ENVIRONMENTAL REVIEW TEAM REPORT

HIGH VIEW APARTMENTS

PLYMOUTH, CONNECTICUT

AUGUST, 1983

FIGURE 2
SITE PLAN

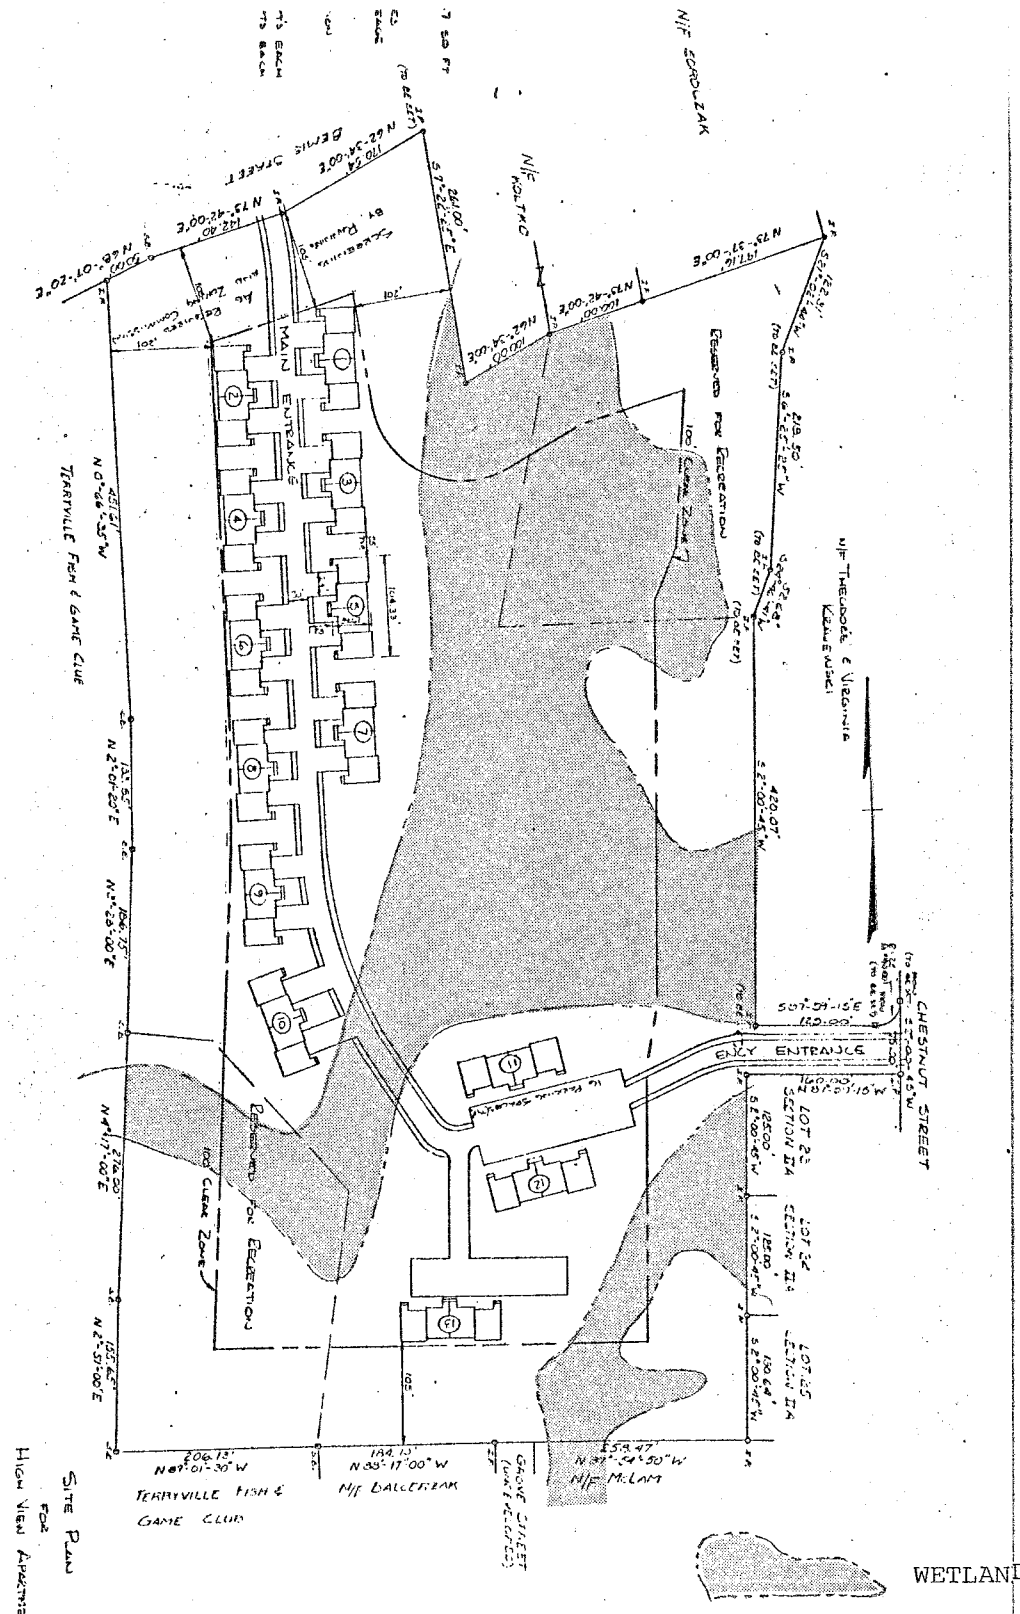
There is an extensive wooded wetland area on the property (see Figure 2). This wetland has value for ground water recharge, nutrient absorbtion, stormwater retention, and wildlife habitat. Leaving the wetlands in its natural state as planned is a good use of this resource. The wetland area will also buffer the development from the adjacent homes.

The wetlands map supplied by the developer is substantially correct. This map however does not delineate the area in which the planned emergency access road runs between the development site and Chestnut Street.

This area is an inland wetland.

Filter fabric fence is a suitable temporary erosion control method. If installed and maintained in the areas where it is shown on the plan, it will help to keep sediment out of the wetlands and on the property. It should be installed downslope from all construction areas, however.The location of this fence should be shown on the site plan.

The construction of the apartment complex should be phased so that the entire site is not under construction at any one time. A minimum of two phases is recommended. The first phase should be completed and seeded to a permanent vegetative cover prior to construction of the second phase. The phases should be shown on the site plan.

Lime, fertilizer and permanent vegetative cover seeding recommendations should be shown on the site plan as should all erosion control measures. This reduces confusion on-site during construction.

The planned energy dissipator is only shown on the site plan at one drain outlet. They should be installed at every drain outlet to reduce the velocity of the water.

The planned crushed stone piles, shown on the site plan as "check dams" in the stream, are likely to cause more problems than they solve in the opinion of the Team's Soil Conservationist. If other erosion and sediment controls are installed properly, very little sediment should be entering the stream course, making these "check dams" unnecessary. If the "check dams" are installed as shown, crushed stone

is likely to be washed throughout the streambed. This would fill the streambed more than the sediment would have. The crushed stone would also reduce the flow capacity of the stream making it more likely to flood.

An intermittent stream flows through the wetland area planned for the emergency access road. This stream could possibly be diverted into the Chestnut Hill storm sewer system. Until it is diverted, a new stream channel should be constructed with project implementation, sized to handle a minimum 25 year, 24 hour storm event. The new channel should direct water out of the proposed road area.

While the proposed emergency access road through this wetland area is feasible with good planning and engineering, an alternate site which avoids wetland disturbance should be used if one can be located.

In the opinion of the Team's Soil Conservationist, sediment controls in the streambed itself are not warranted with implementation of the proposed project. If, however, such controls are to be included with the plan, a preferable alternative to the "check dams" would be a carefully designed and constructed settling pond where the access road crosses the stream. Again, this is not viewed as necessary; but, in the opinion of the Team, would be better than the proposed "check dams".

FIGURE 7
ALTERNATE ACCESS ROAD

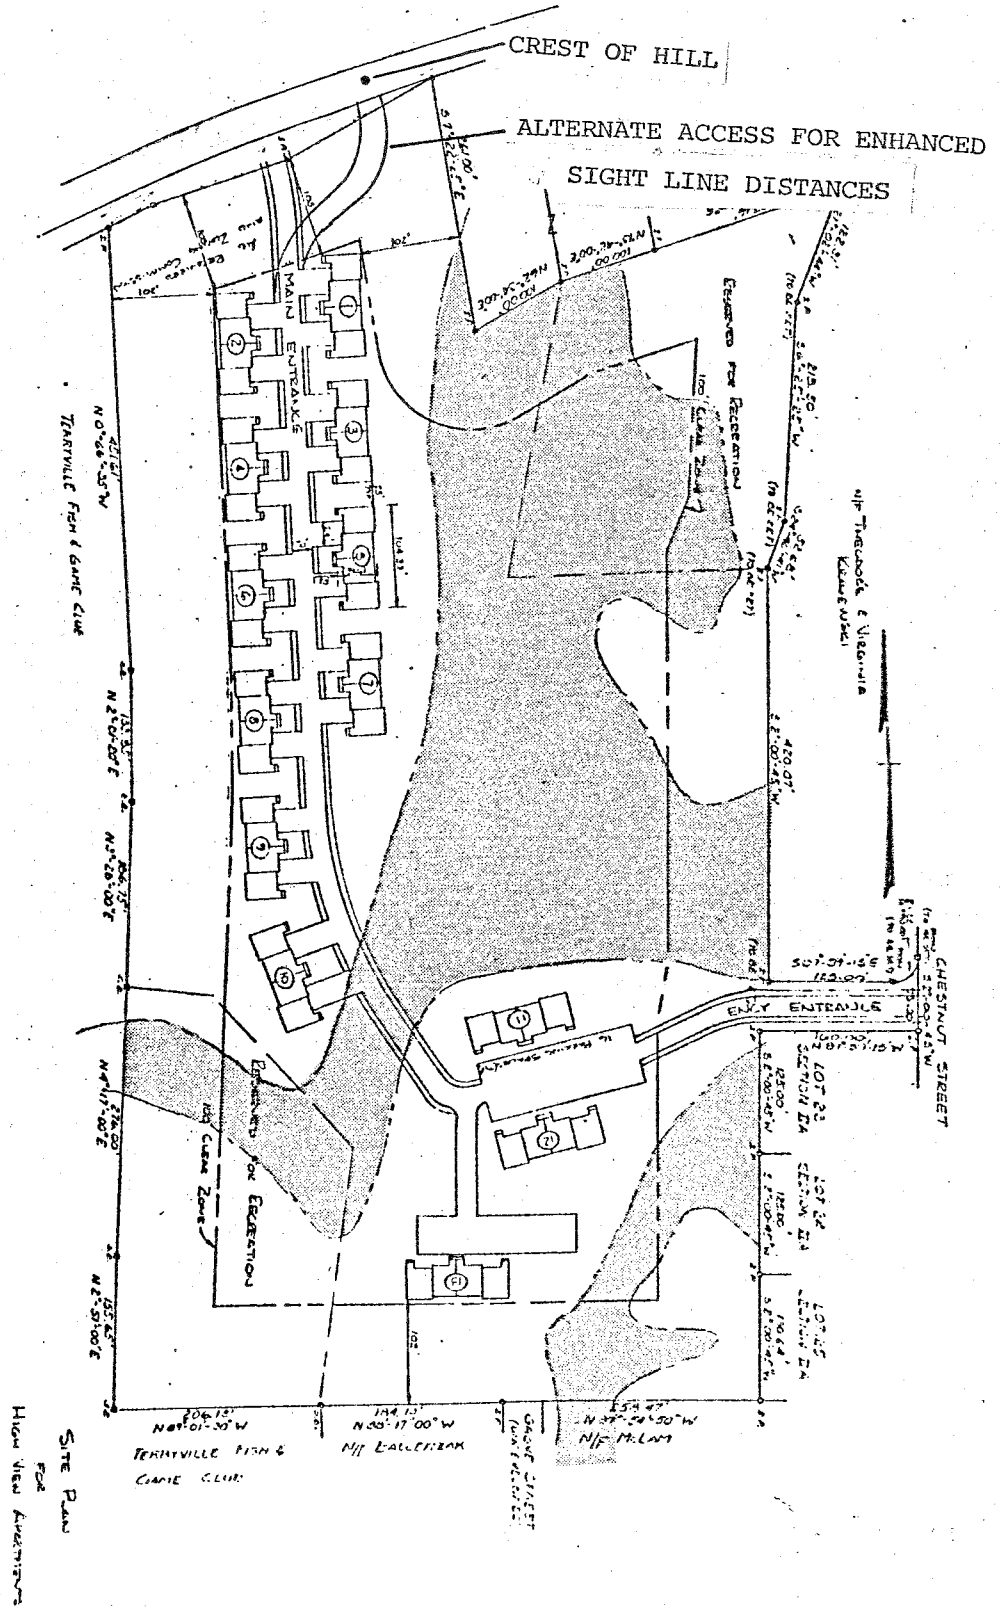
Consideration should be given to relocating the proposed access road off Bemis Street approximately 100' to the east. Sight line distances to the east from the current access are restricted due to a dip in the road at the eastern edge of the property. By moving the access road ± 100' easterly to the crest of the hill, sight line distances to the east will be markedly improved. This alternate access road could tie in to the presently proposed road as shown in Figure 7.
